Re: *FAA Initiative Phase 1*, SFO Airport/Community Roundtable Response

SFO AIRPORT/COMMUNITY ROUNDTABLE RESPONSE TO FAA INITIATIVE

**EXECUTIVE WORKING OUTLINE
SFO AIRPORT/COMMUNITY ROUNDTABLE RESPONSE TO FAA INITIATIVE**

**EXPANDED PROCEDURE DISCUSSION PACKAGE
SFO AIRPORT/COMMUNITY ROUNDTABLE RESPONSE TO FAA
INITIATIVE**

WOODSIDE AND MID-PENINSULA

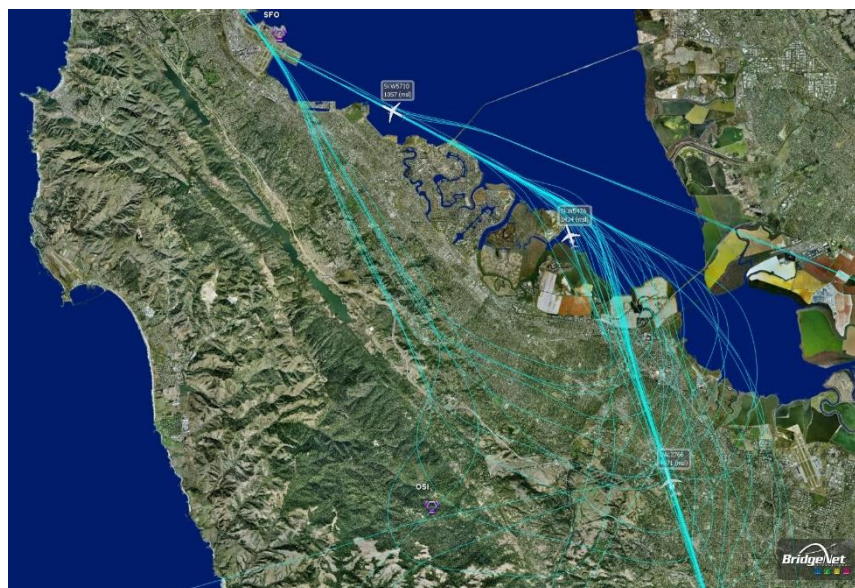
2. BDEGA Arrivals from the North and West: The SFO Roundtable is available to provide data to the FAA regarding terrain and land use for aircraft arriving on the BDEGA east leg and can work with the FAA to move the east downwind leg of the arrival over compatible land uses. In order to reduce vectoring on the Peninsula, the SFO Roundtable requests the FAA to increase in-trail spacing on the SERFR Arrival, on the DYAMD Arrival (to allow an increase in the BDEGA East Downwind, and determine if an increase in the BDEGA in-trail spacing would decrease vectoring.

1. The SFO Roundtable is available to provide data to the FAA regarding land use areas to assist in keeping procedures over compatible land uses as much as feasible during the day. The goal during the nighttime hours is to avoid flight over noise-sensitive land uses as much as feasible, even if it means a few additional track miles.
2. The SFO Roundtable will work with airline representatives to request that during the night time hours, airlines file oceanic flight plans that follow the path of BDEGA arrival for an FAA assigned east downwind for Runway 28R (down the Bay procedure) instead of flying over the peninsula.
3. The SFO Roundtable will work with airline representatives to request that during the night time hours, airlines file routes from the south to a point east of the Bay in order to use a noise-friendlier approach to Runway 28R.

1. Determine if the BDEGA transition to FINSH can be reinstated. If so, determine a timeline for this revised procedure to be included for publication.

2. The SFO Roundtable requests that the FAA research to compare the previous Golden Gate arrival with the current BDEGA arrival to determine what changes have been made in actual flight tracks with regard to location of lateral paths, narrowing of path and concentration of aircraft. The previous Golden Gate arrival directed aircraft to fly a 140° heading after SFO/BRIXX, but the BDEGA directs aircraft to fly a 140° track after BRIXX. While this change seems minor - flying a track instead of a heading - it would result in a more concentrated invariable path, contrasted with using a heading, which, depending on the direction and velocity of wind could create somewhat dispersed paths.

3. The SFO Roundtable requests that the FAA research reasons for the continued increased use of the BDEGA west leg from May 2010 – present.

PROCEDURE: Visual Arrivals, Foster City Arrivals	ADJUSTMENTS: 1.b.iii., 1.b.iv., 1.b.v.
---	---

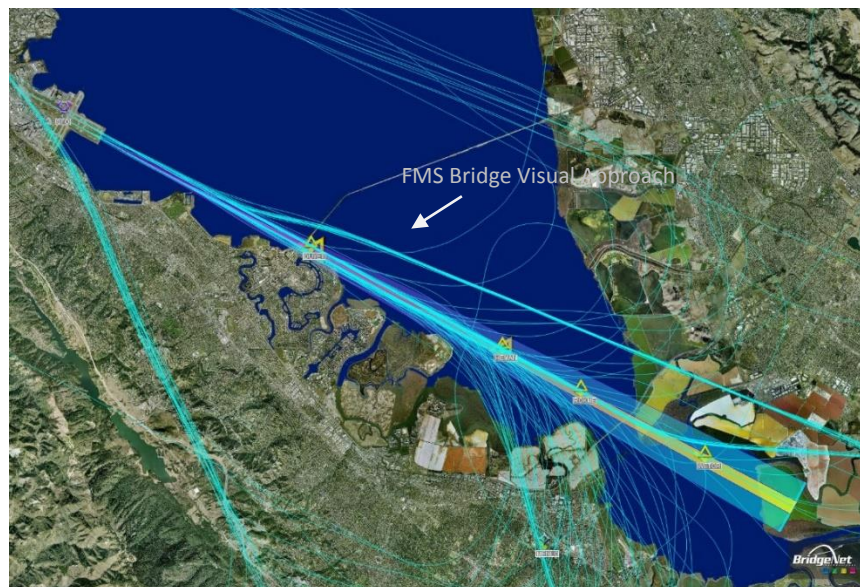
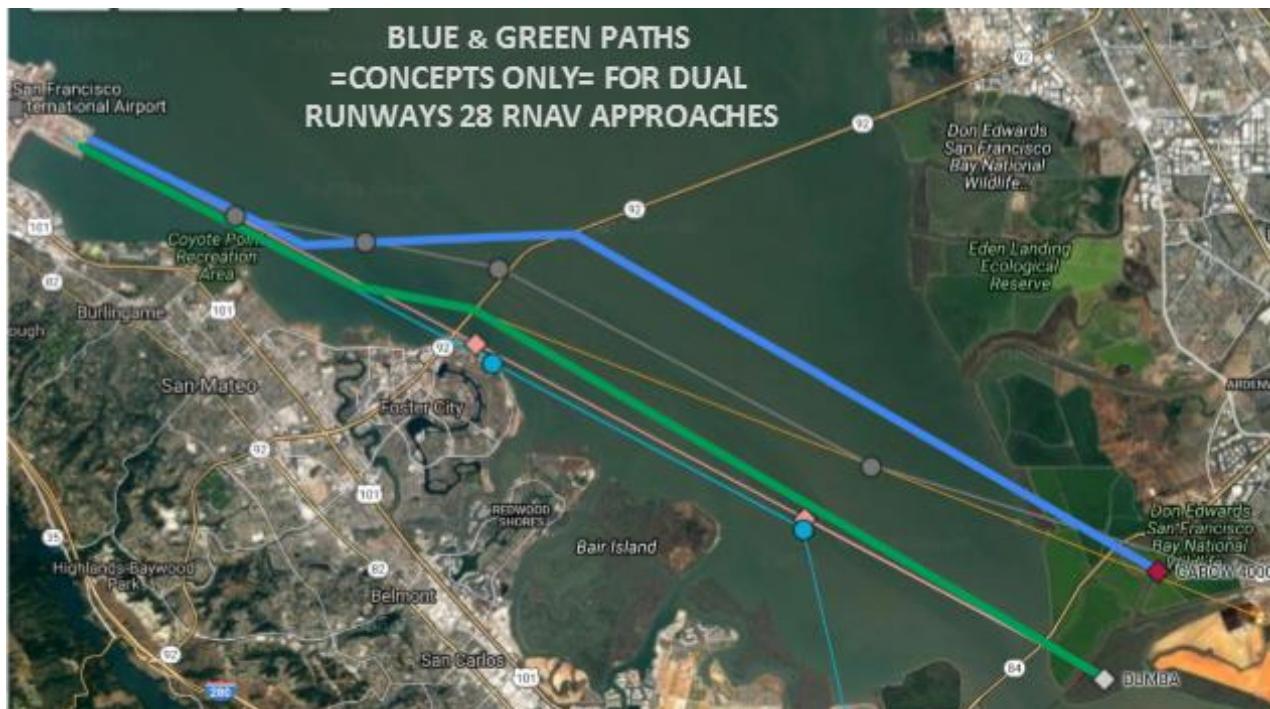
1. The SFO Roundtable will work with NCT management to illustrate the importance of the use of Runway 28R instead of Runway 28L during periods of single stream operations and the critical nature of nighttime operations which might require managing arrival traffic to create a single stream of traffic to 28R.
2. The SFO Roundtable will provide information and community input to the FAA regarding the process of creating, if feasible, of dual satellite-based Runway 28L and 28R offset approaches closer to the middle of the Bay.

NIITE Procedure

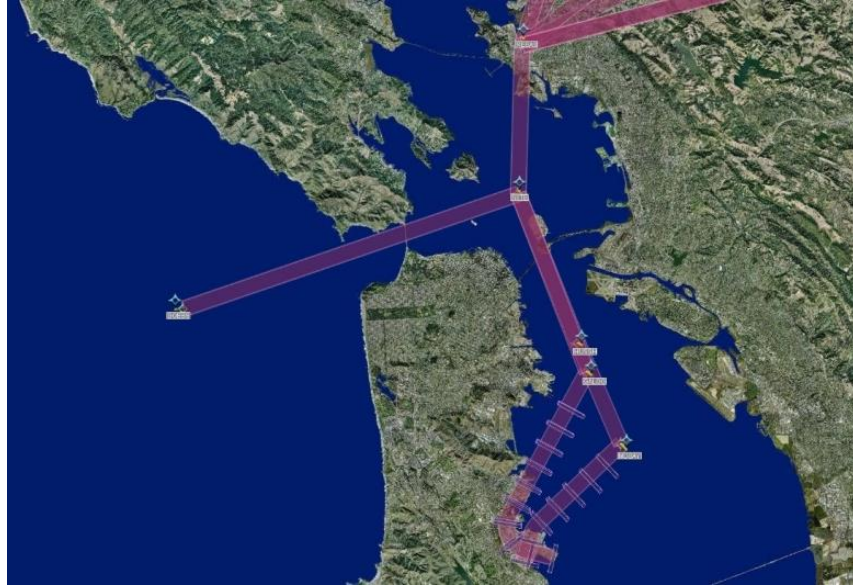
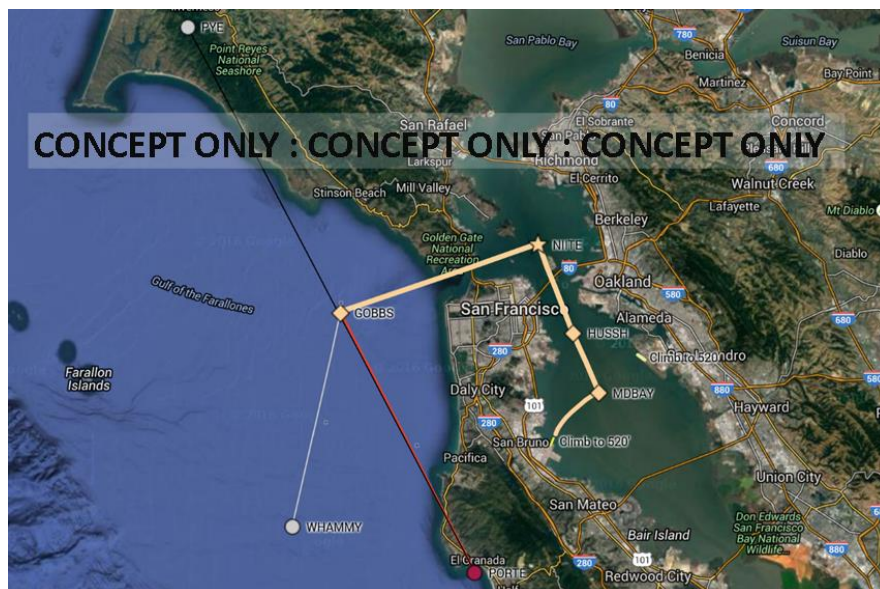
1. Southbound Transition: While undergoing the formal process of amending the NIITE departure to add a transition for southbound aircraft past GOBBS and adopting GOBBS for use, the Roundtable requests that NORCAL TRACON work with the SFO RT to determine if an interim informal procedure based on TRACON vectors might be feasible during the nighttime hours only to approximate the NIITE departure which would be heading up the Bay to NIITE, then west to GOBBS, then south-south-east to the PORTE or WAMMY waypoint, remaining clear of the shore. While the Roundtable is asking for the NIITE procedure to be used, it is not requesting increased use of Runway 01 L/R for departures, especially at night.

1. NIITE Southbound Transition: The SFO Roundtable is in agreement with FAA Initiative Adjustment 2.f.i and formally requests that the FAA add a transition to the NIITE departure for southbound aircraft.

Without presuming to technically design such a south transition, it would seem that this highly desirable southbound destination transition *might* be comprised of a single, simple “add-on” leg, using the existing NIITE departure to the GOBBS waypoint, and thence via already largely existing waypoints and flight paths mirroring much of the PORTE departure to PORTE intersection. In addition, the routing of the OFFSHORE departure may present an additional option using the WHAMMY waypoint. The SFO Roundtable understands that the design of professional flight procedures encompasses far more than a line drawn on a map, and understands that airspace use and airspace restrictions are significant challenges in this process.

The possible southbound transition for the NIITE departure depicted above contains just two concepts to consider. The “add-on” paths depicted seem desirable not only because they keep aircraft largely over the Pacific Ocean, but

also because a significant portion of the “add-on” paths are routinely used in the PORTE and OFFSHORE departures. Many other paths for this southbound transition could be designed that would also keep aircraft over the ocean.

1. The SFO Roundtable will provide input regarding the new southbound transition and will elicit community input and response to the design of the new NIITE southbound transition and Runway 10 L/R NIITE authorization.

PROCEDURE: Opposite Direction Operations	ADJUSTMENTS: 2.e.i., 2.e.ii., 2.e.iii., 2.g.i., 2.g.ii.
---	--

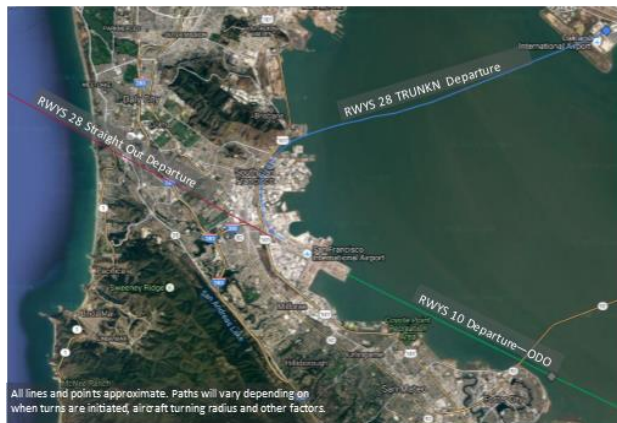
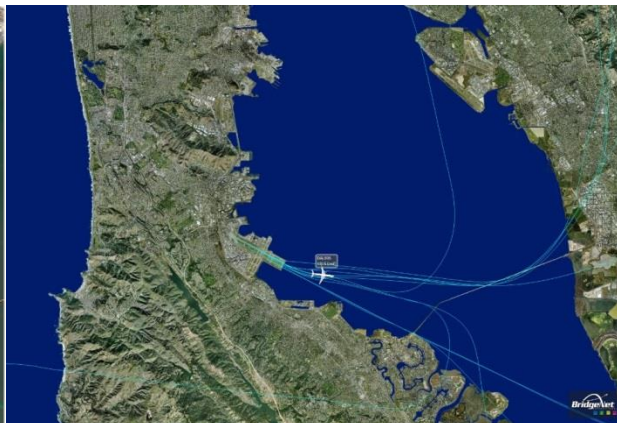
1. It should be determined if any VFR flyway results in Runway 28 straight-out departures being assigned a 3,000' altitude restriction. If so, determine if a modification of any VFR flyway is warranted in the current Class B Airspace Modification process to allow unrestricted climbs for SFO Runway 28 jet traffic. If the altitude restriction is due to other factors, determine if the other factors can be modified to allow unrestricted climb.
2. Create a procedure that includes the ability of aircraft to depart Runway 10 L/R on a heading that isn't in the direct path of aircraft arriving on Runway 28, such as making an immediate left turn after takeoff or flying to the east of the Runway

28 arrival path to provide lateral separation; for vertical separation, use altitude restrictions for the departing aircraft.

3. Create a Runway 10L/R RNAV departure that mirrors the decommissioned DUMBARTON EIGHT procedure, keeping aircraft over the bay to gain altitude before turning. Mirroring the DUMBARTON could include making adjustments to SAHEY to ensure aircraft will remain over the bay before turning towards their destination.

1. The SFO Roundtable will provide information to the FAA to assist in a review of options for aircraft to use Runway 10 L/R that does not use the same flight path as a Runway 28 L/R arrival.
2. The SFO Roundtable urges the consistent use of effective noise abatement procedures such as the long-standing TRACON nighttime noise abatement procedure for aircraft taking off from Runway 10, to fly an approximate 330° heading up the Bay and thence out the Golden Gate.
3. The Roundtable will work with the FAA to re-design the SAHEY departure to mirror historic flight tracks that keep aircraft over the bay.

SSTIK
Departure, SFO and CNDEL Departures, OAK

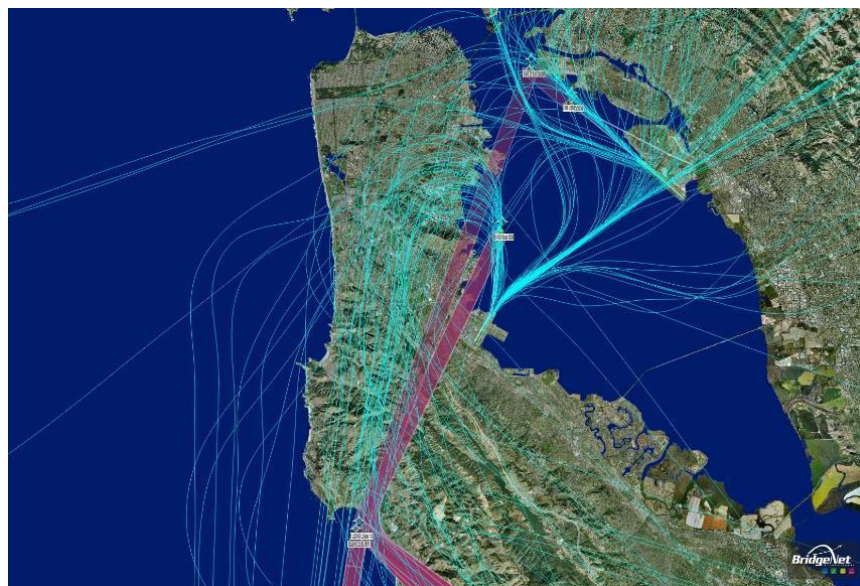
7. The Roundtable understands the additional complexities added to air traffic controllers by depicting city locations or densely populated areas on radar displays. However, the Roundtable would like to determine the feasibility of depicting the SEPDY waypoint on the scopes in an effort for aircraft to stay over the Bay as long as possible. This would allow aircraft additional time to climb over the Bay before turning.

1. The SFO Roundtable will provide community input to the FAA to find an appropriate location for moving the SSTIK waypoint east and north of its current location, again using SEPDY as a guide, so planes can fly over the Bay for a longer period of time, and thus increase altitude before heading west and flying over residential areas.
2. Request the FAA provide modeling or other tools to determine the effects of different waypoint options.
3. The SFO Roundtable requests the FAA to allow planes to fly the charted procedures and to reduce vectoring and when safety is not an issue as well as to use higher altitudes when flying over noise-sensitive land uses and the use of non-residential areas where feasible.
